## INTRODUCTION

Since the introduction of the THM 440-T4 Transaxle in April, 1984, there have been many major engineering design changes. These changes have affected nearly every part used in the THM 440-T4. This Update Handbook will explain each change, the parts affected by the change, and any parts interchangeability problems created by the change.

### THM 440-T4 PUMP INFORMATION

Figure 69

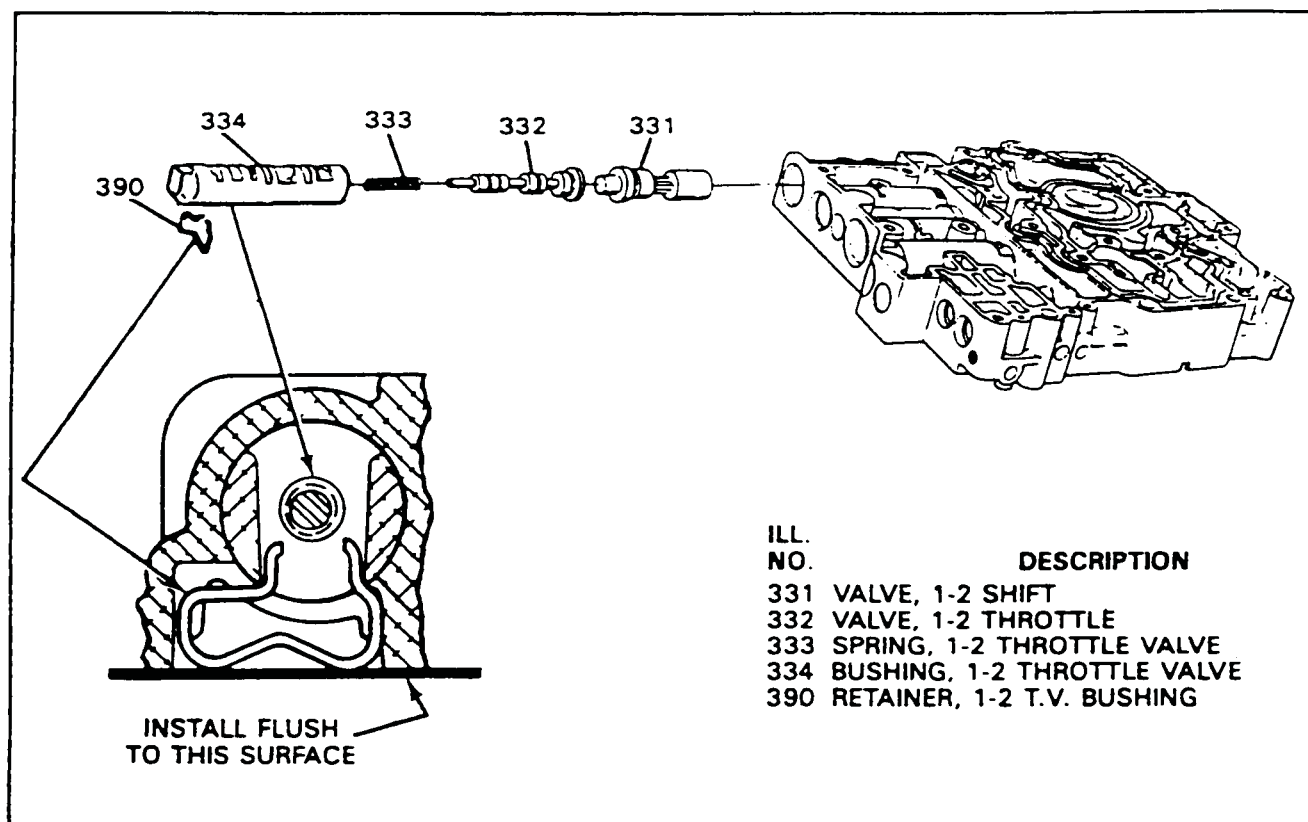
CAUSE: The cause may be the 1-2 throttle valve bushing retainer (390) pushed in too far (See Figure 69). If the retainer is pushed in too far the "Legs" of the retainer will grab hold of the 1-2 throttle valve, and the result will be 2nd gear starts.

CORRECTION: Install the retainer so that it is flush with the machined surface of the valve body (See Figure 69).

NOTE: The bushing must be installed as shown in Figure 69, with the angled surface on the end of the bushing toward the channel plate.

Figure 70

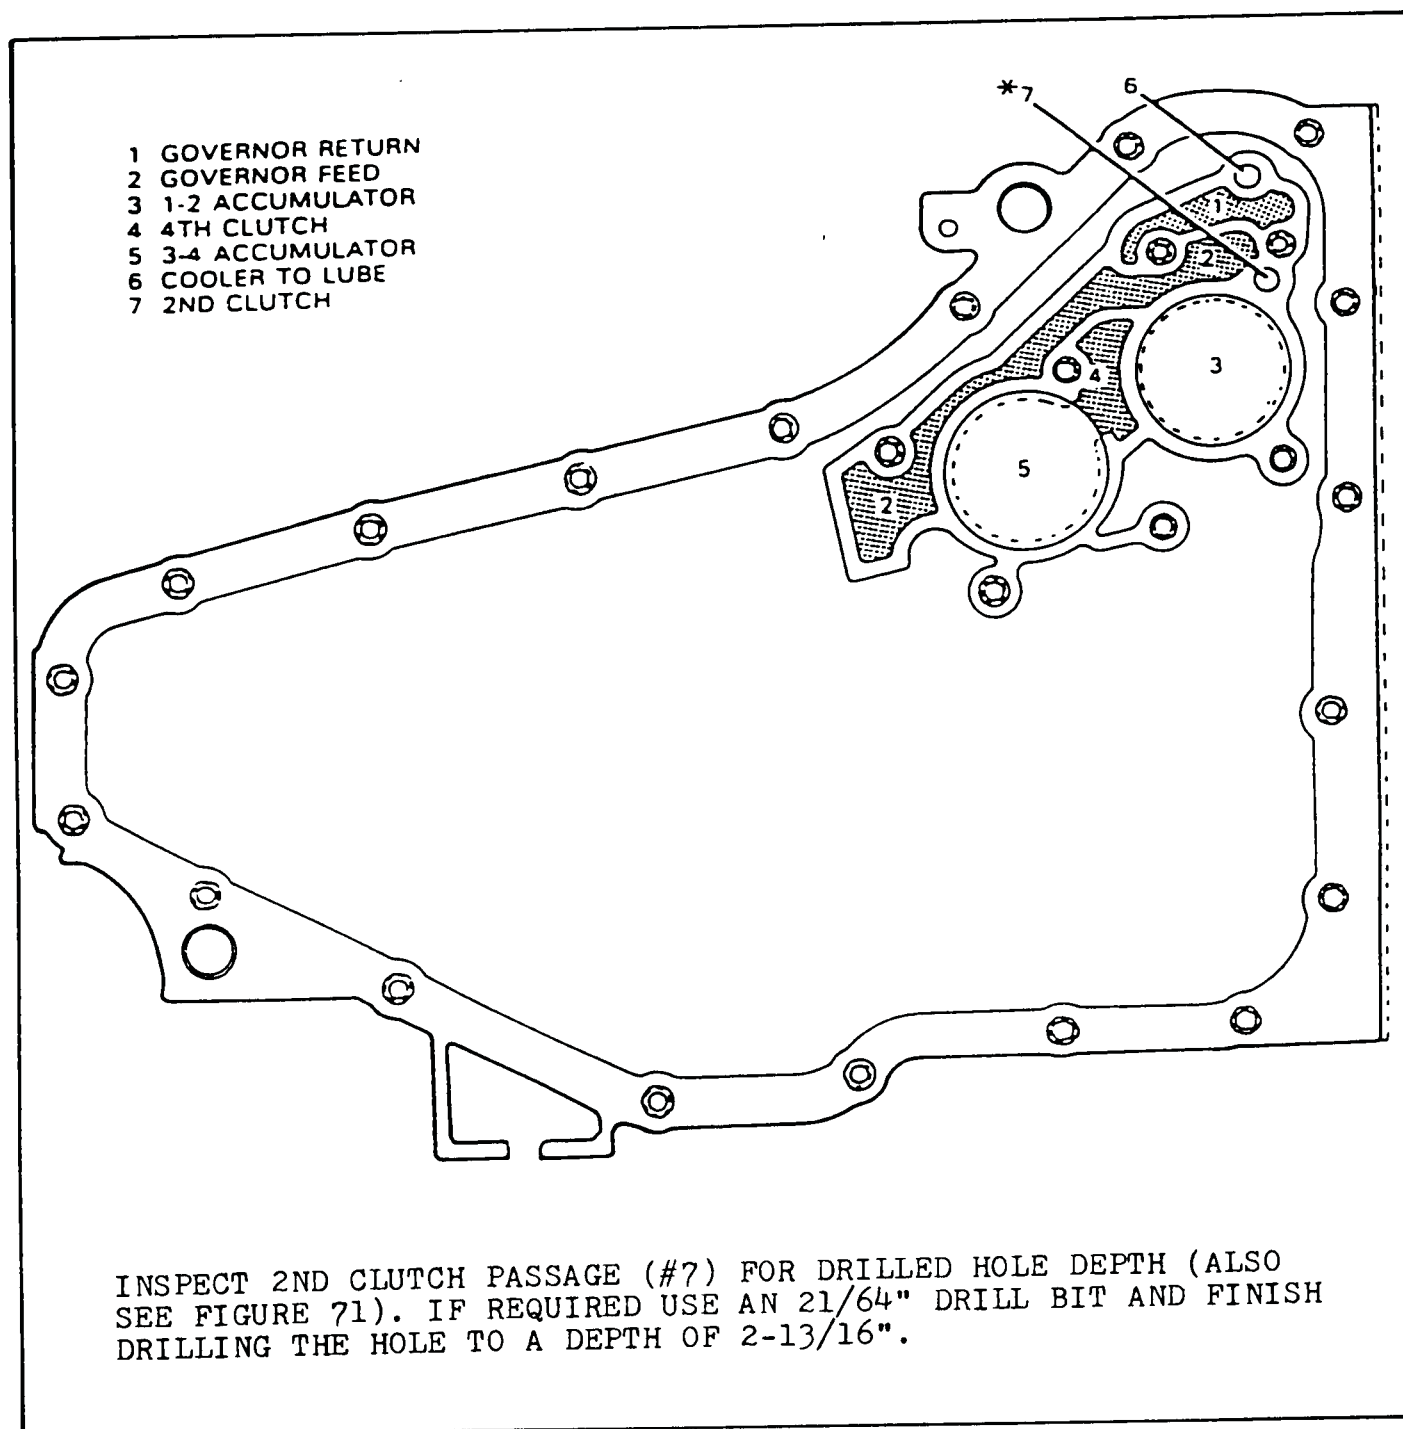
- COMPLAINT: Consistently harsh 1-2 shift condition at any throttle angle and any altitude.
- CAUSE: This harsh shift condition may be caused by a blocked, or partially drilled 2nd clutch feed passage in the case.
- CORRECTION: To repair this condition inspect the 2nd feed passage, #7 in Figure 70, for blockage or incomplete drilling operation. To perform this inspection, remove the trans-axle oil pan, filter, accumulator cover (With feed pipes and retainer), accumulator cover spacer plate and gaskets. Inspect the 2nd clutch passage by measuring the depth of the hole, which should be a minimum of 2-13/16" as shown in Figures 70 and 71.

1. Remove the transaxle from the vehicle and disassemble components up to and including the channel plate.
2. Mark a 21/64" drill bit at 2-13/16" from the end using a drill stop or tape. From the oil pan side of the case, finish drilling the 2nd clutch passage to the proper depth as marked on the drill bit.

Figure 72

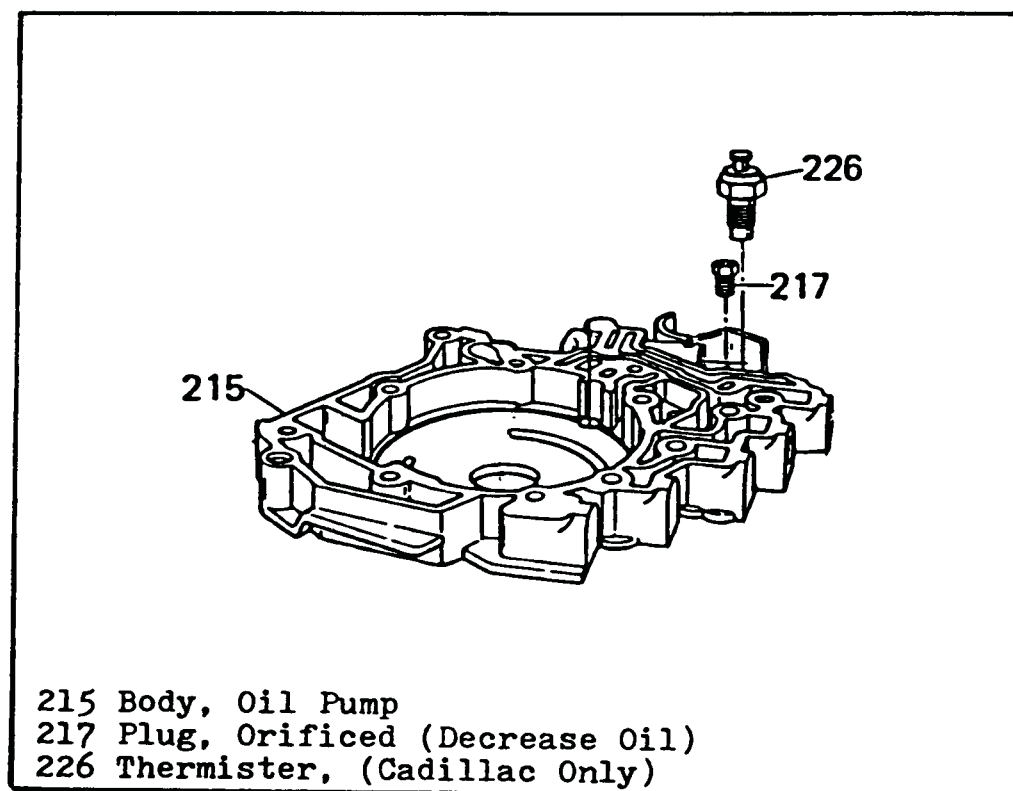
**CHANGE:** Thermister located in oil pump housing moved into cooler line (See Figures 72 & 74). Temperature switch in channel plate was also eliminated (See Figure 73).

- (1) Thermister - Removed from pump housing (See Figure 72).
- (2) Temperature Switch - Eliminated (See Figure 73).
- (3) Cooler Line - Temperature Sensor added (See Figure 74).
- (4) Case Connector - "E" terminal that normally carried the thermister wire is now empty (See Figure 75).
- (5) Vehicle Wiring Harness.

Figure 76

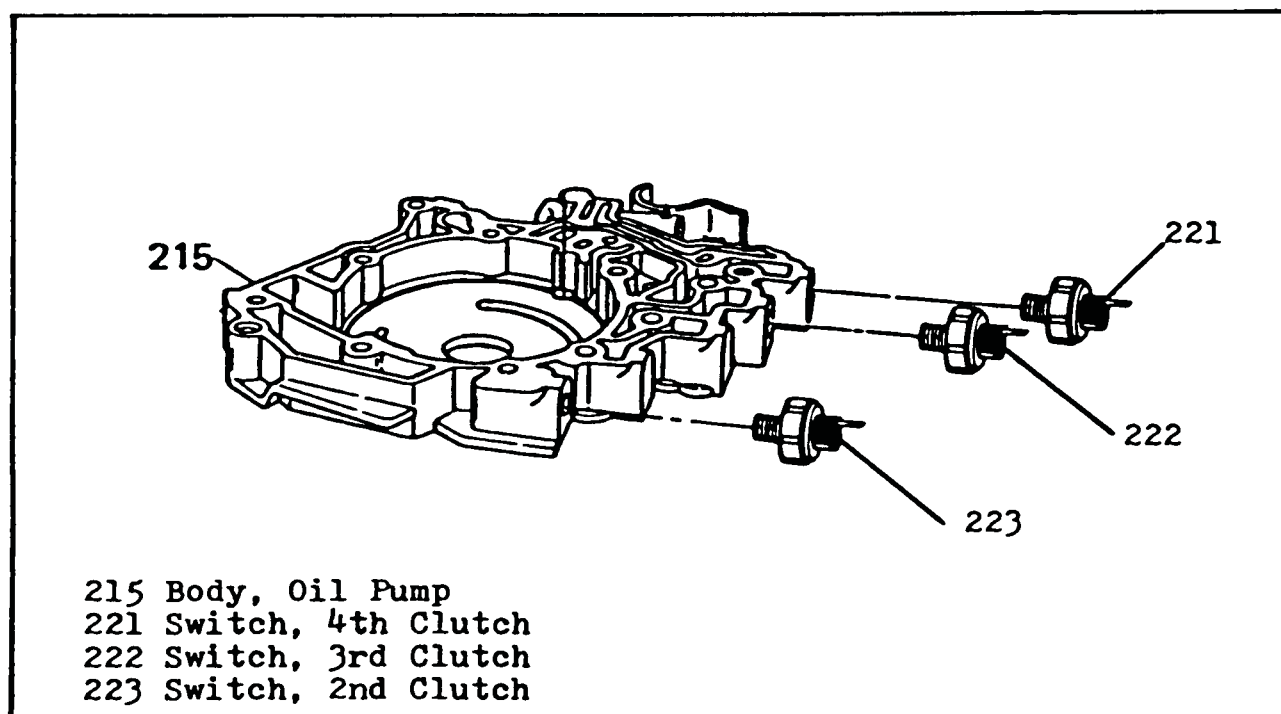
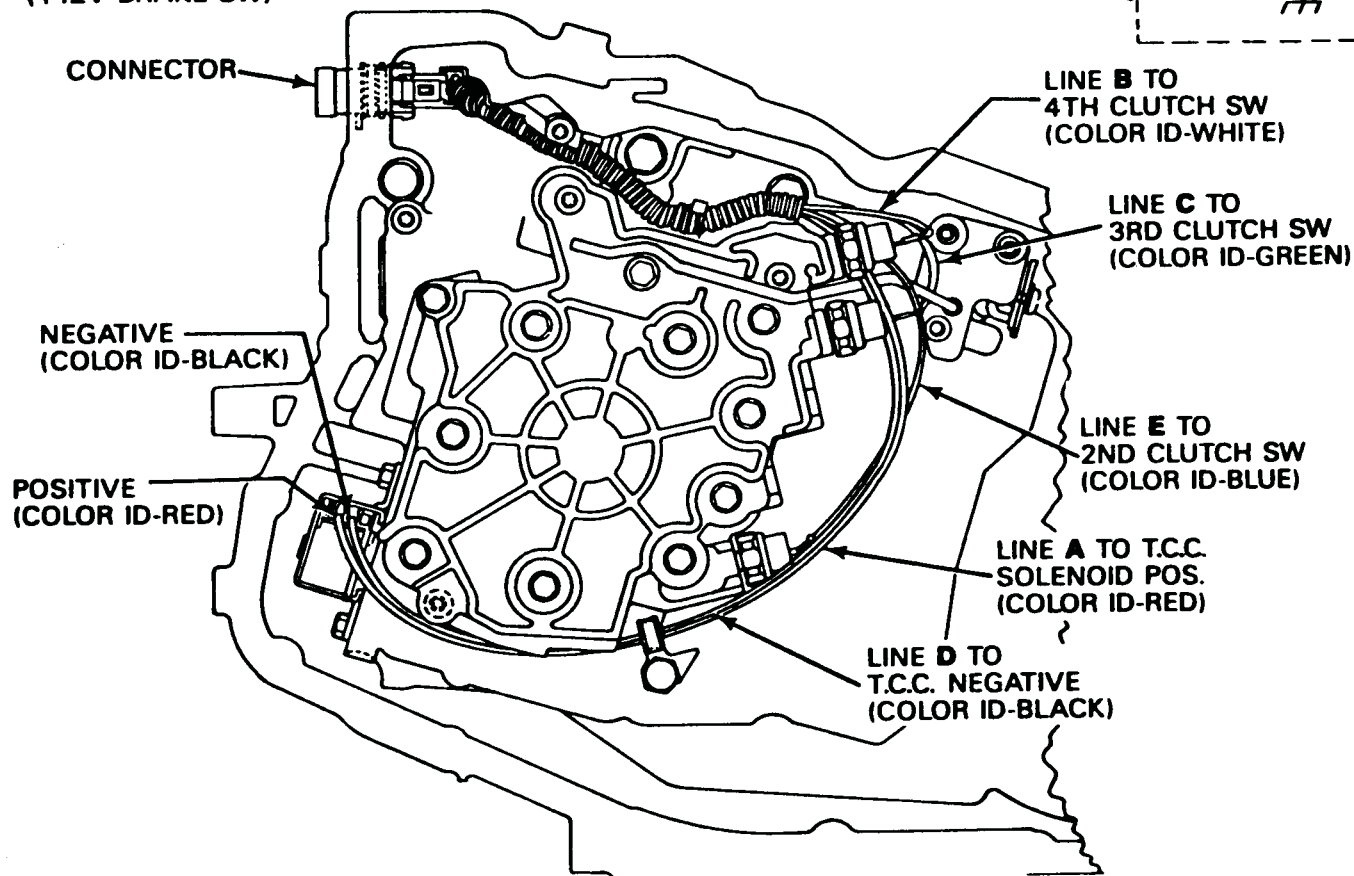
- (1) Pump Body - Drilled and tapped for 2nd clutch switch.  
(See Figure 76).
- (2) Valve Body - Extra hole drilled in valve body to carry 2nd clutch oil to pump body.
- (3) Case Connector - Now round black connector (Same as Cadillac), and "E" terminal now carries 2nd clutch signal wire (See Figure 77).
- (4) Transaxle Wiring Harness - Extra wire in harness for 2nd clutch signal to ECM (See Figure 77).
- (5) Vehicle Wiring Harness

Figure 80

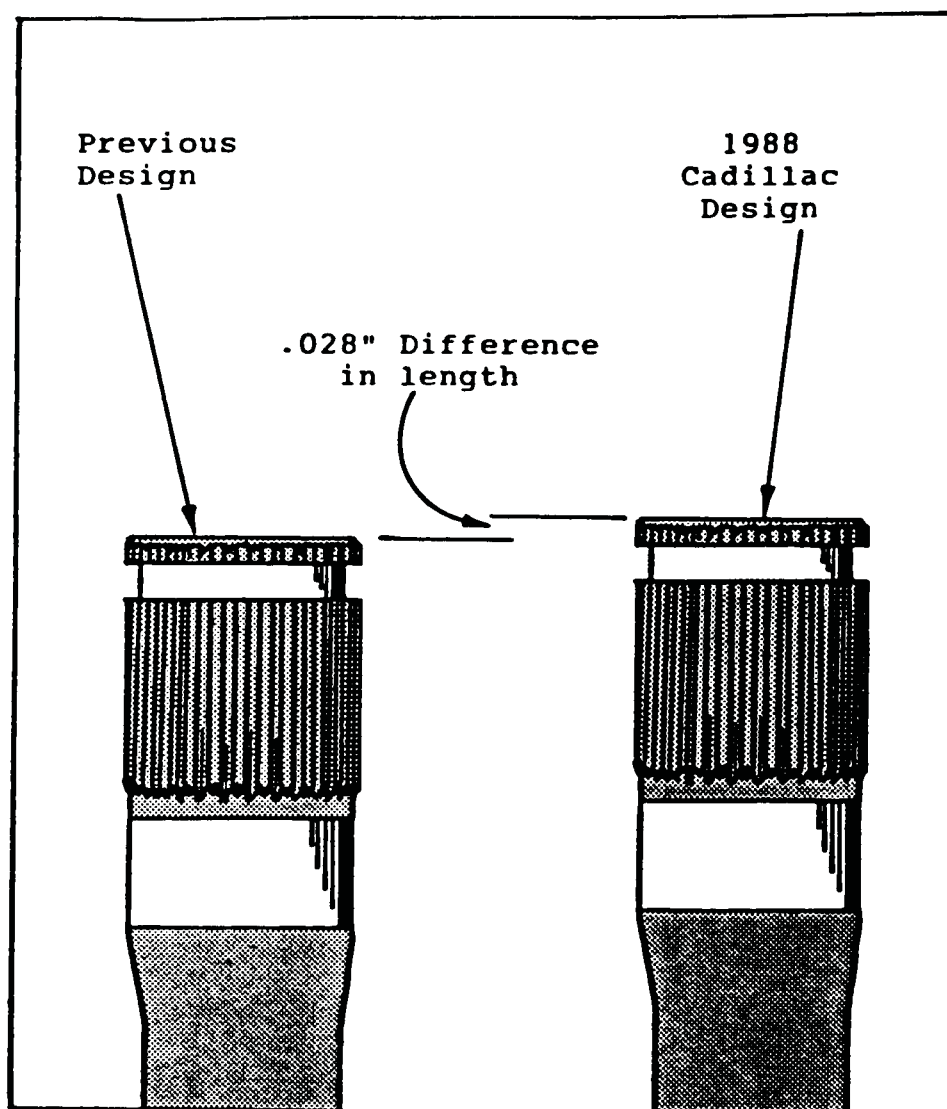
- (1) Differential Side Gears - Revised dimension (Thicker), and they have 16 teeth instead of previous 15.
- (2) Differential Pinion Gears - Revised dimension, and have 10 teeth instead of previous 11.
- (3) Side Gear Thrust Washers - Revised dimension.
- (4) Pinion Gear Thrust Washers - Revised dimension.
- (5) Differential Housing - Revised dimensions (Internal), to accept new side gears and new pinion gears.
- (6) Differential Pinion Shaft - Black in color to identify the new design final drive assembly (See Figure 79). Also is a smaller diameter.
- (7) Output Shaft - Longer (.028"), so that it will extend through the thicker side gears, to get "C" clip installed. The longer output shaft can be identified by green paint on the end of the shaft opposite the "C" clip end (See Figure 80).

Figure 82

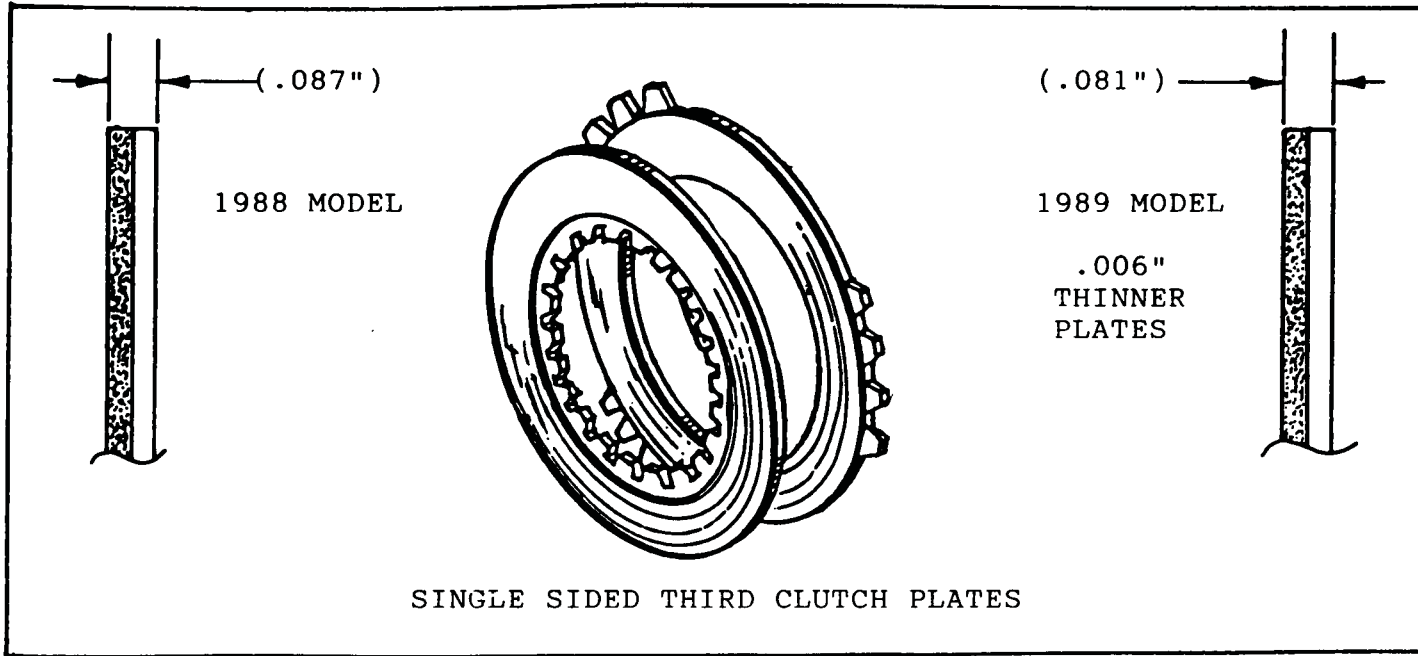
- (1) Single Sided 3rd Clutch Plates - Both inside and outside spline plates are .006" thinner for 89, to make room for the two additional plates (See Figure 82).

Figure 84

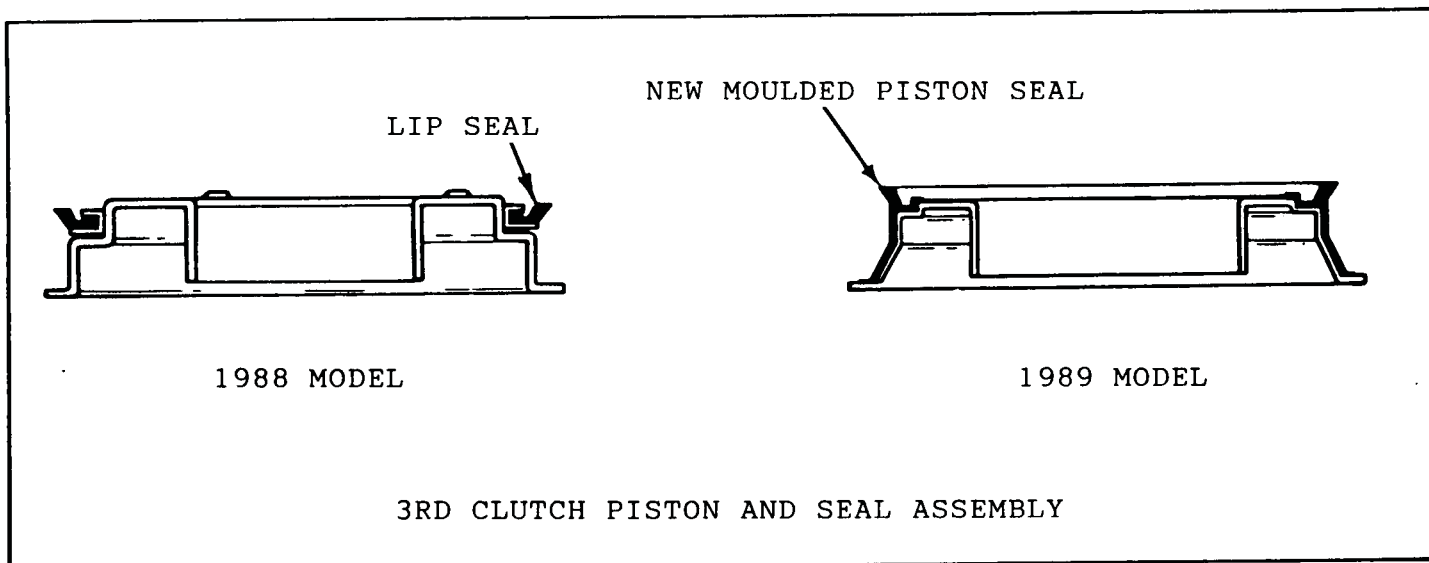
- (2) 3rd Clutch Piston Housing - Was decreased in overall size for calibration considerations (See Figure 83).
- (3) 3rd Clutch Piston - The 3rd clutch piston outer seal is now moulded to the 3rd clutch piston (See Figure 84).

Figure 85

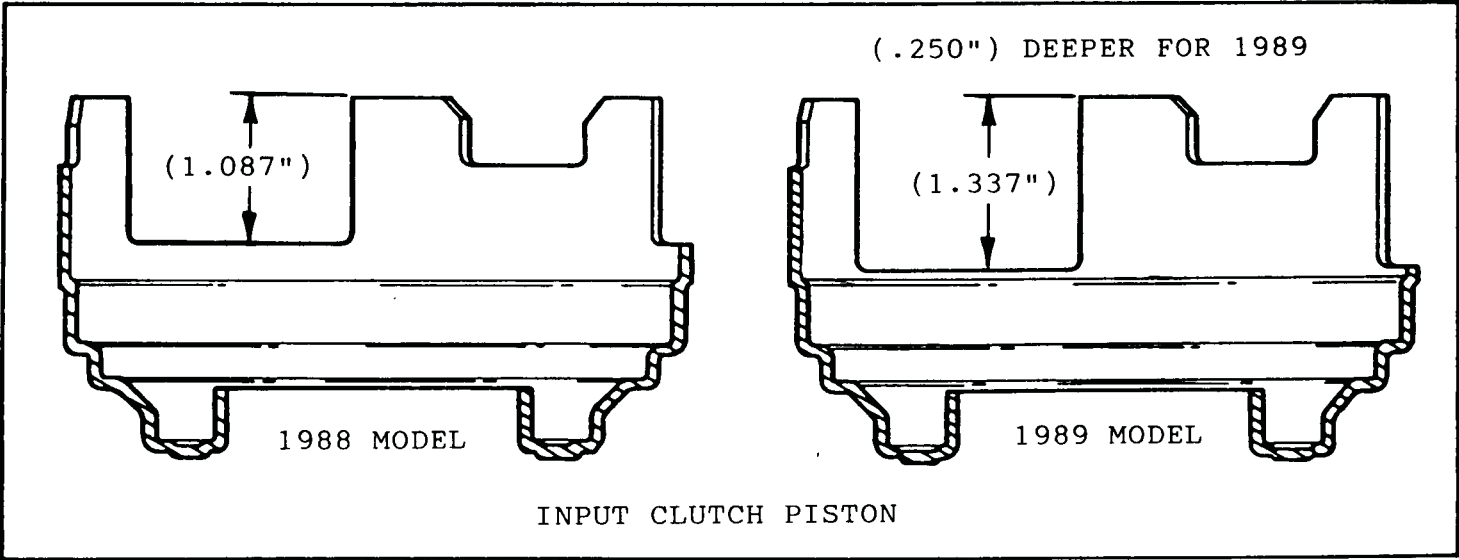
- (4) Input Clutch Piston - The cutouts in the piston for the 3rd clutch plates are .250" deeper to accomodate the additional two clutch plates in the 3rd clutch pack (See Figure 85).
